proposed
APARTMENT BUILDING

at
35-37 NUNDAH ST
NUNDAH

PLANS AND DOCUMENTS
referred to in the REFERRAL
AGENCY RESPONSE

SARA ref: 2608-53862 SRA

GROUND FLOOR

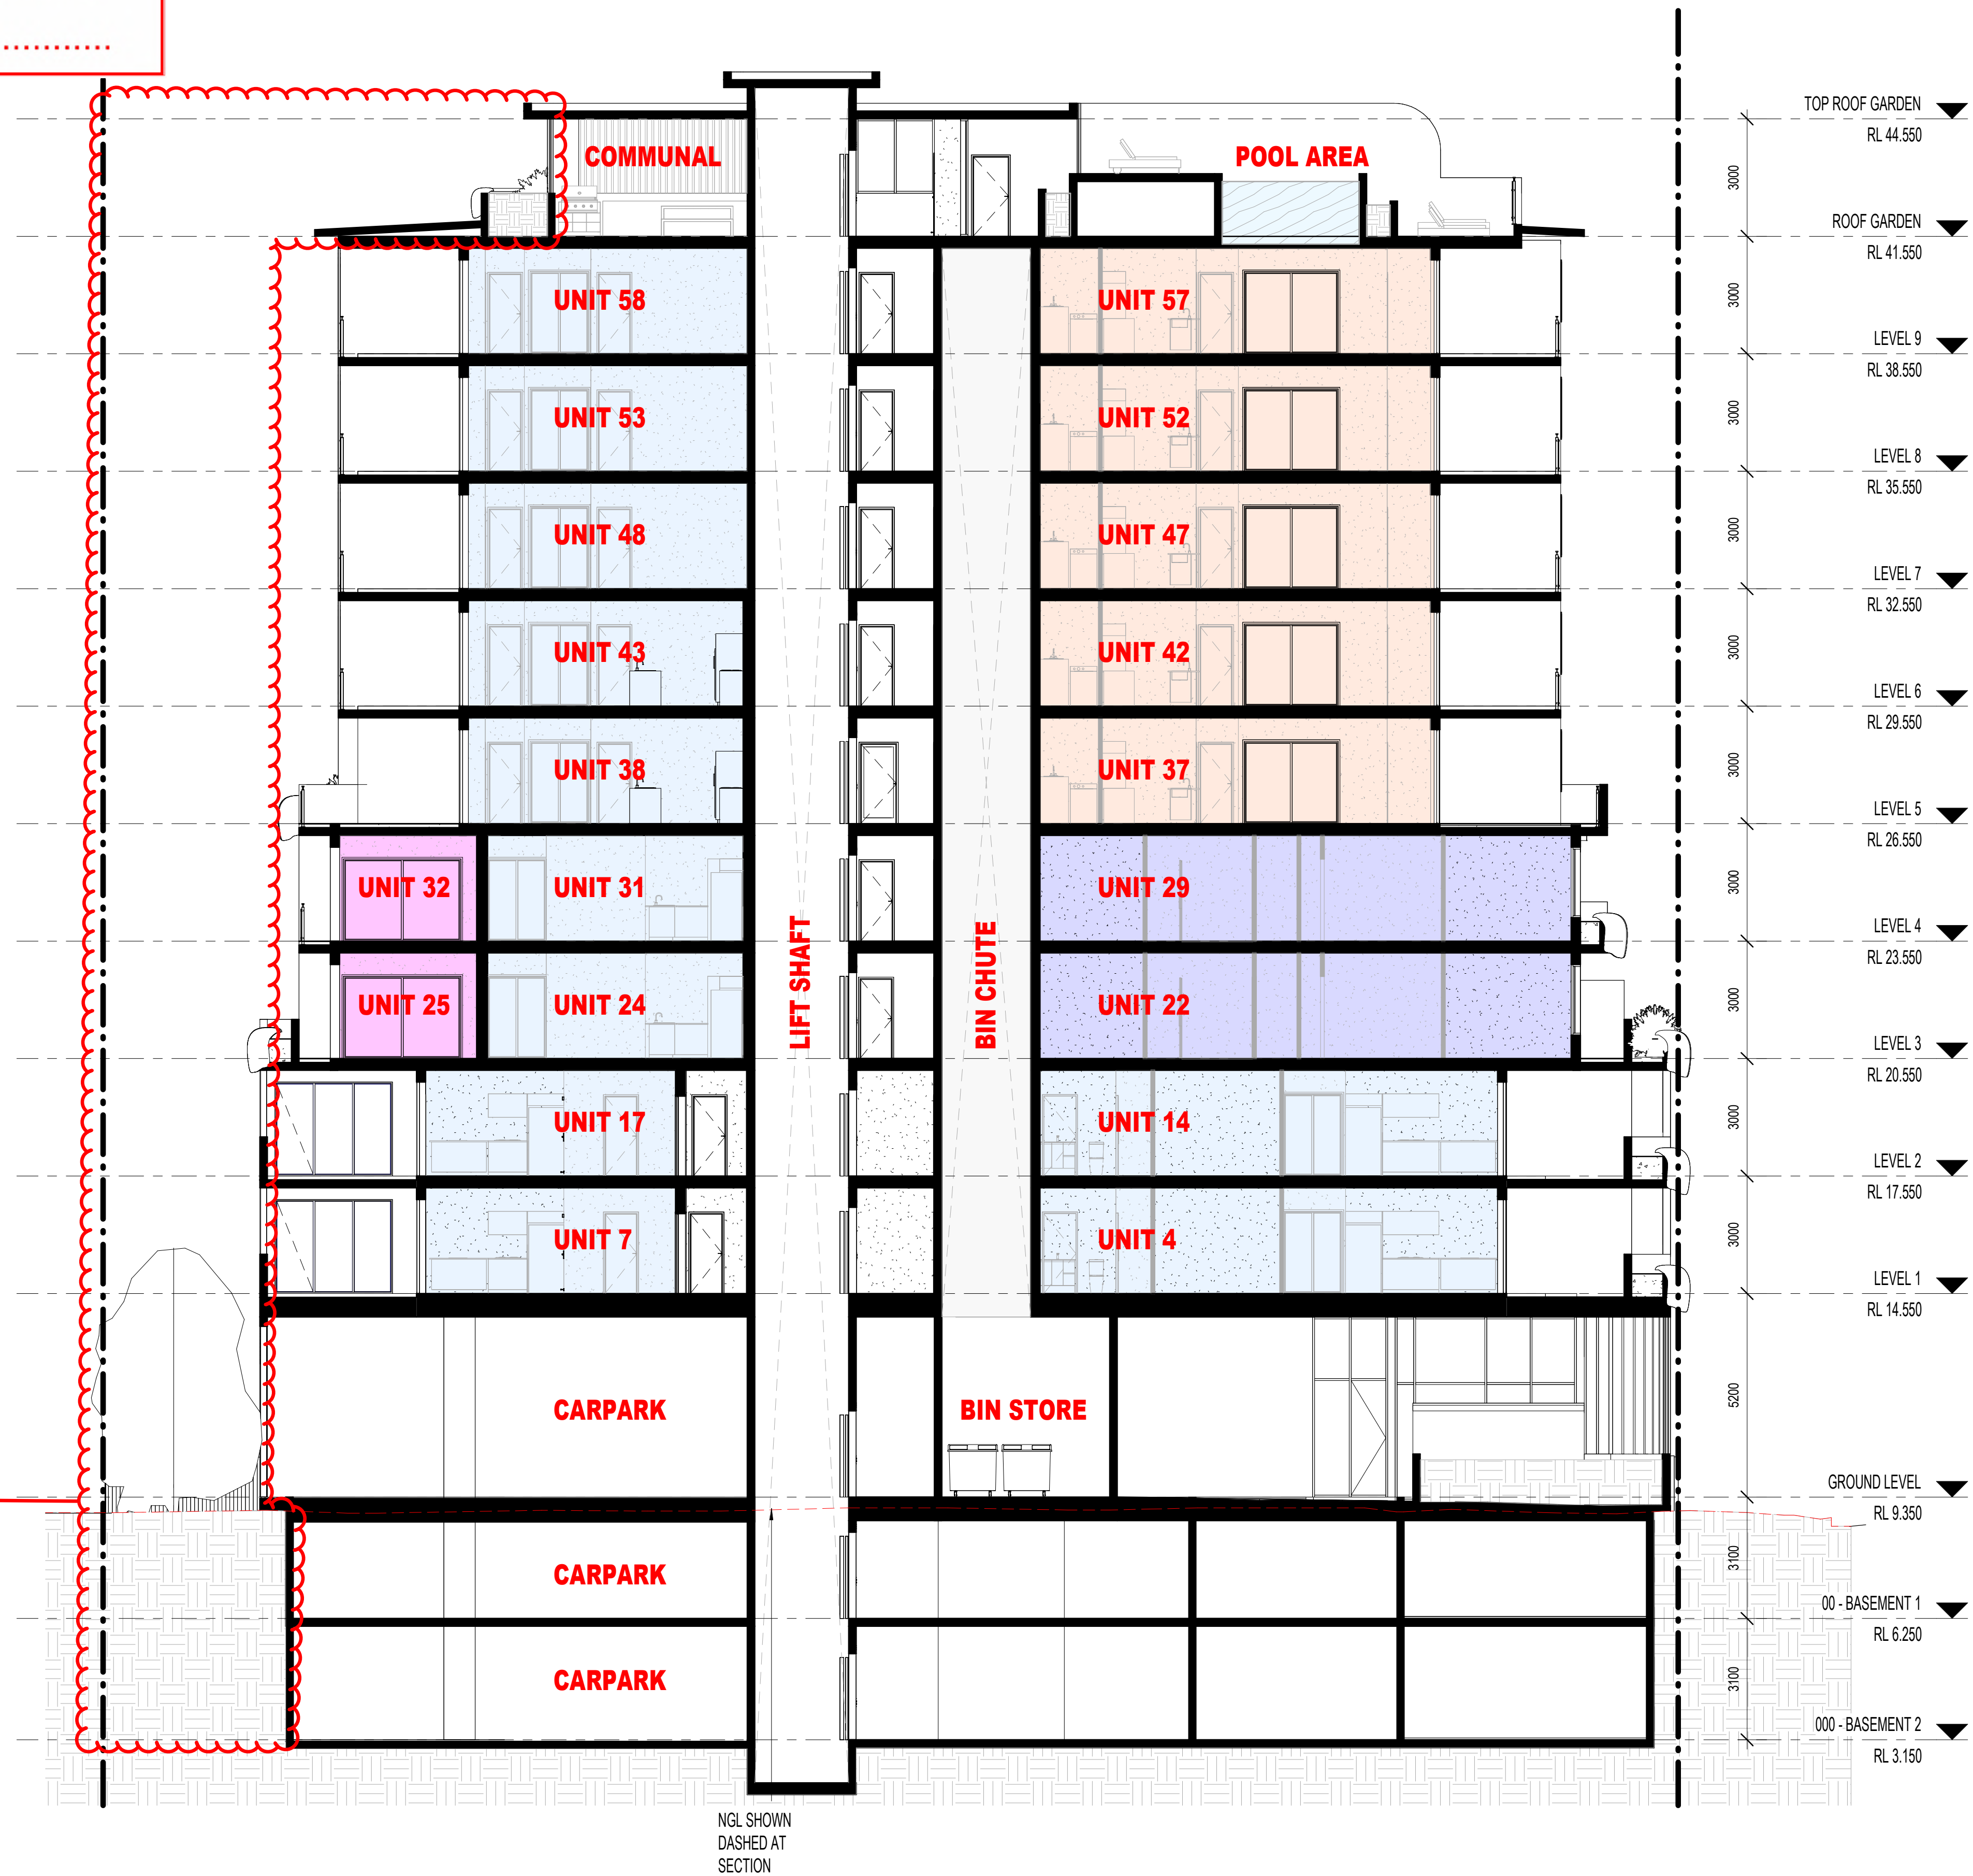
Amended in red by SARA on
4 September 2026

Minimum building wall setback to be 4.0 metres from the site boundary with the railway corridor, extending from ground level to the top of the building for the eastern facade per Condition 1 of the referral agency response
